## Sundry Notices and Reports on Wells

5. Lease Number  
NMNM - 03179  
6. If Indian, All. or  
Tribe Name  
7. Unit Agreement Name  
8. Well Name & Number  
Aztec 8E  
9. API Well No.  
30-045-23751  
10. Field and Pool  
Basin Dakota/Otero Chacra  
11. County and State  
San Juan Co., NM

Attached is a letter and documentation requesting an exception for an MIT performed 2/9/10.

Figure 1: Setup for MIT.

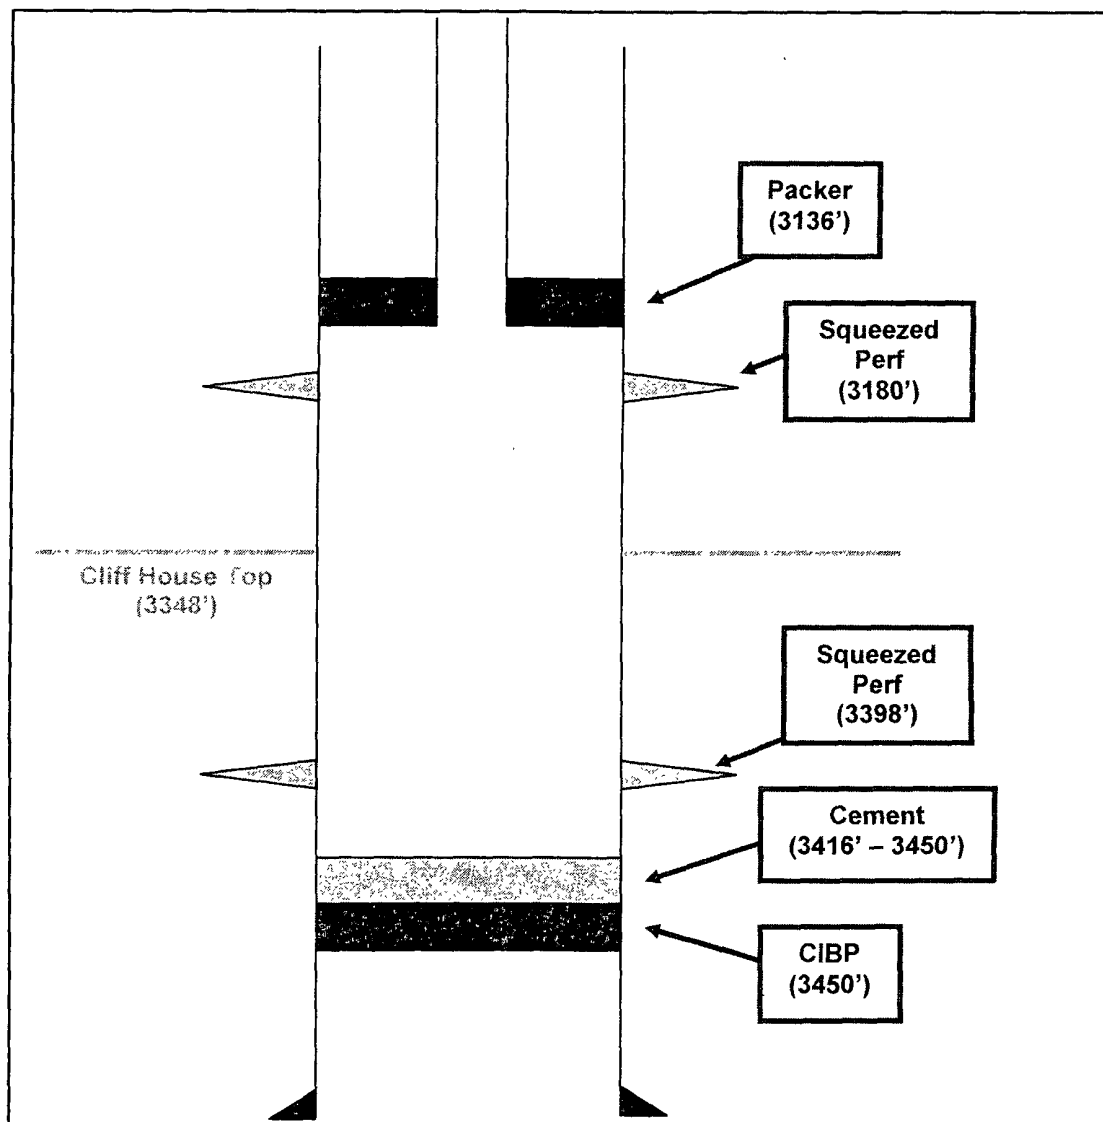
The area in question is the section between 3136' and 3416' of the casing (Figure 1). On February 9, 2010 we had drilled the cement from 3293' to 3416' between 10:00 am to 12:45 pm with an air/mist. We circulated the hole clean, tripped out of hole, and then set a packer at 3136' at 3:15 pm. We immediately loaded the hole with 2% KCL water and began a Mechanical Integrity Test (MIT) on the casing from 3136' to 3416' that lasted from 3:15 pm to 4:30 pm. In that time, the pressure in the casing went from 560 psig to 600 psig in 23 minutes. The decision was made to restart the test to help relieve some of the pressure caused by completing the test so soon after we filled the hole with fluid. The pressure was relieved to 500 psig. The test lasted for 66 minutes and the final pressure was at 640 psig. The pressure after 30 minutes was 580 psig. The test was verbally confirmed with Derrick, the NMOCD field representative, and then sent in to the NMOCD office. Tubing and rods were landed and the rig moved off location.

Figure 2: Estimated Pressure Exerted on the Casing During the MIT.

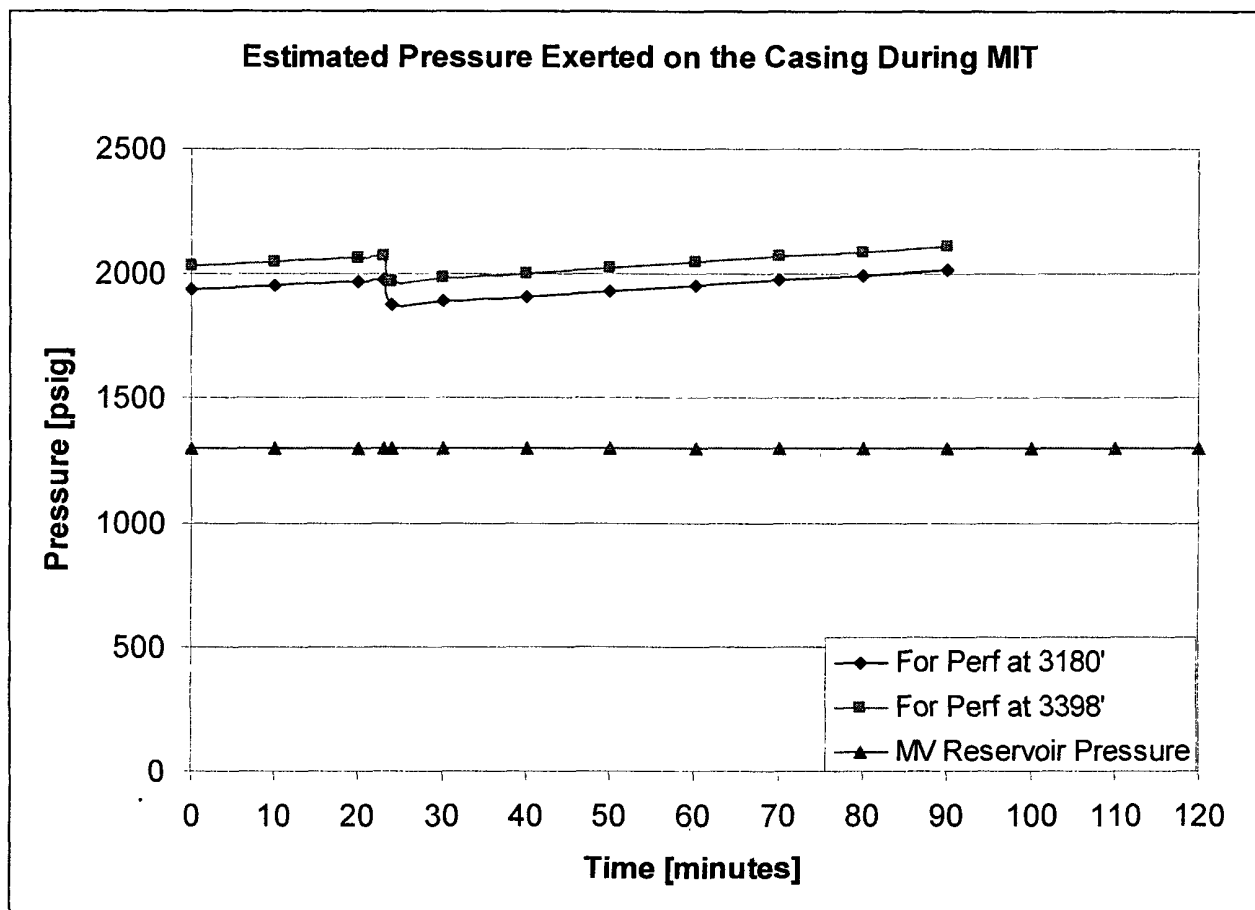
The reservoir pressure of the Cliff House formation is approximately 1300 psi in this area, 28N-11W-14. This is based off of a pressure gradient from the outcrop. The calculated pressure exerted on the squeeze perforations during the MIT test is between 1930 psig and 2110 psig (Figure 2).

Figure 3: Estimated Surface Gauge Pressure During MIT.

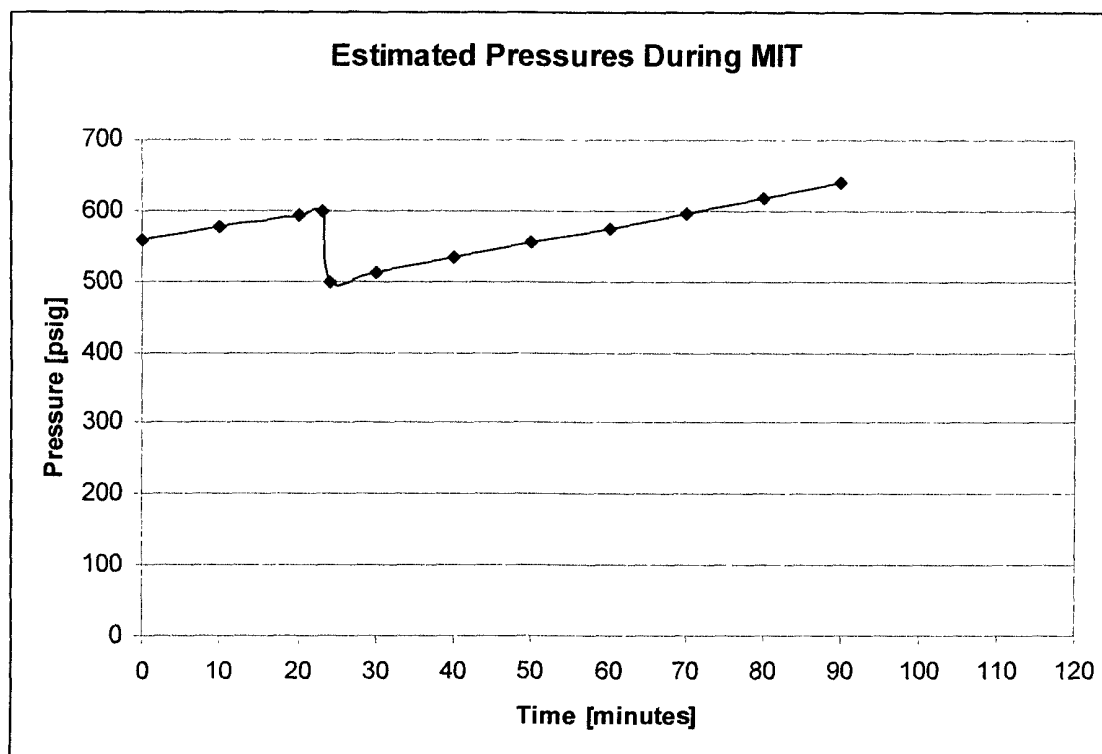
The estimated pressures on the perforations are calculated using the hydrostatic gradient of 0.433 psi/ft and the corresponding depths plus the gauge pressure on the surface. Figures 3 and 4 show the approximate gauge pressure on the surface during the MIT from the two hour chart. With that said, the increase in pressure could not possibly be coming from the formation. There is at least a differential of 630 psi between the formation pressure and the pressure exerted on the squeeze perforations. The increased pressure must be coming from the combination of cold fluid in the casing and tubing, hot casing from drilling the cement, formation temperature, and the fact the test was started immediately after filling the hole with fluid.
